**THAMES TIDEWAY TUNNEL – PINS REFERENCE WW010001**

**WRITTEN SUMMARY OF ORAL CASE PUT AT 4-5 FEBRUARY HEARINGS ON BEHALF OF THE  
FREE TRADE WHARF MANAGEMENT COMPANY LIMITED**

1 This is a summary of the oral case put at the 4-5 February 2014 issue-specific hearing on noise and vibration issues on behalf of Free Trade Wharf Management Company Limited (FTWMCL).

**Document Information**  
**Application for Development Consent**  
Construction phases - phase 2  
Shaft construction  
Book of plans - section 25  
DCO-PP-24X-KEMPF-250016  
January 2013

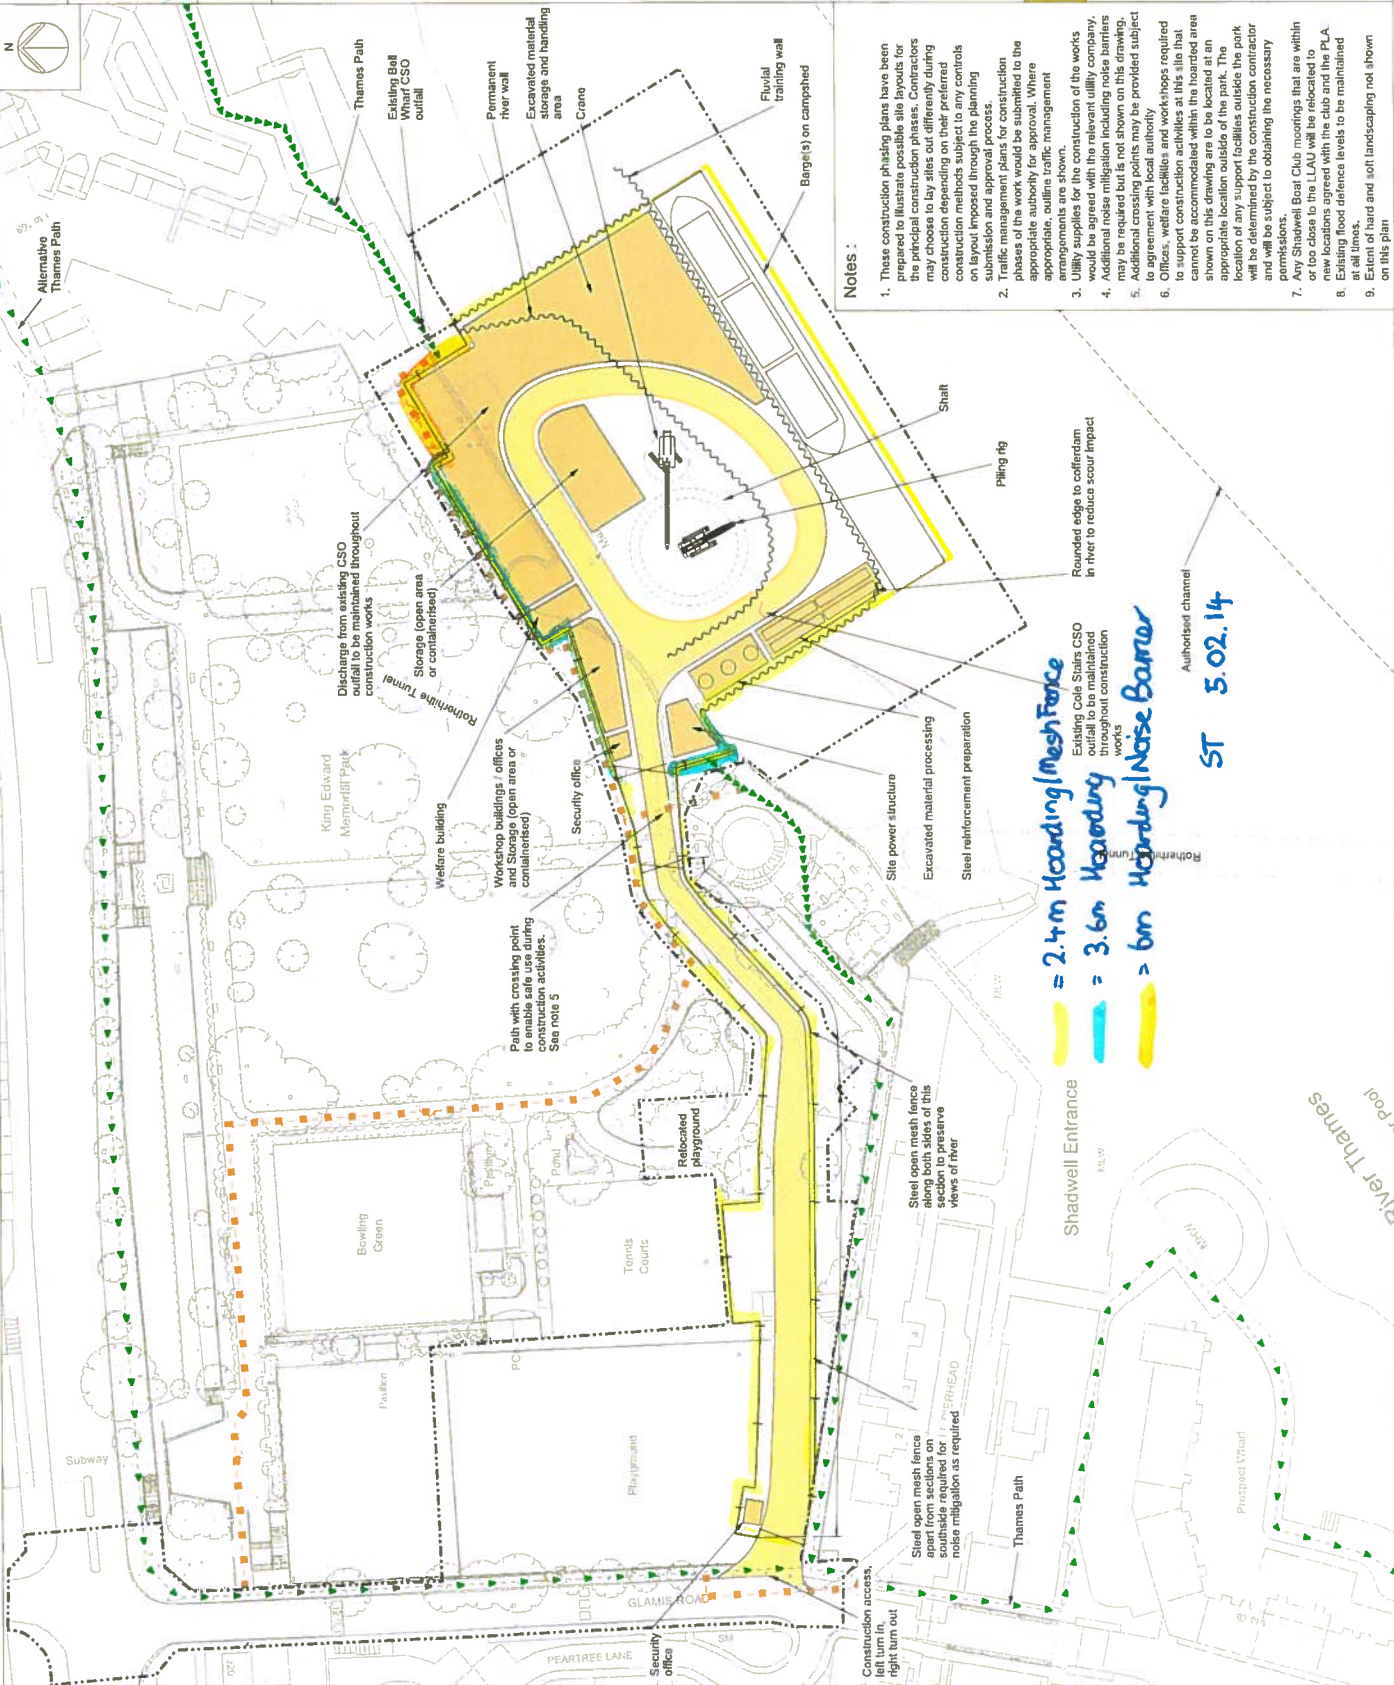
- 9 Thames Water has provided FTWMCL with a plan showing where the different heights of the hoardings now proposed would be sited, for which it is grateful (see the Appendix to this document). The proposed section of 6m hoarding is not wide enough to prevent noise impacts from being heard at Free Trade Wharf around its edges. A 6m hoarding is also too low to shield the higher floors of Free Trade Wharf. FTWMCL does not wish the hoarding to be higher, but believes that noise impacts cannot be adequately mitigated at this location without other knock-on adverse impacts such as visual amenity and safety of navigation, and that an alternative should be promoted, namely the Heckford Street and Park option.
